# Service Bulletin

Bulletin No. 2013-14R1

## Propeller Shaft P/N 44-888530 No Longer Available (NLA)

Notice
Revised April 2015. This bulletin supersedes the previous bulletin number 2013-14, October 2013.

54149

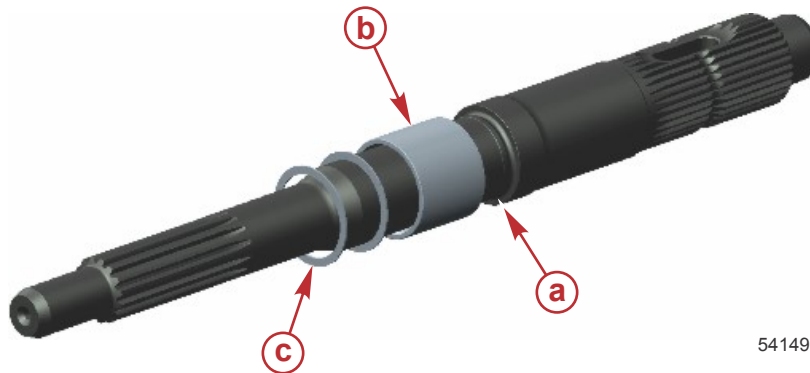
The previous propeller shaft part number 44-888530 has been made NLA and must be replaced by ordering a new propeller shaft, new thrust spacer, and shims or shim set as required from the following table. The previous thrust spacer and shim set will continue to be offered to service the part number 44-888530 propeller shaft only.

- a** - Propeller shaft, area of machining change
- b** - Thrust spacer, longer
- c** - Shims, hardened

## To Replace a P/N 44-888530 Propeller Shaft You Must Order

Note: A shim set, part number 8M0076745, is available that includes one each of the individual shims listed.
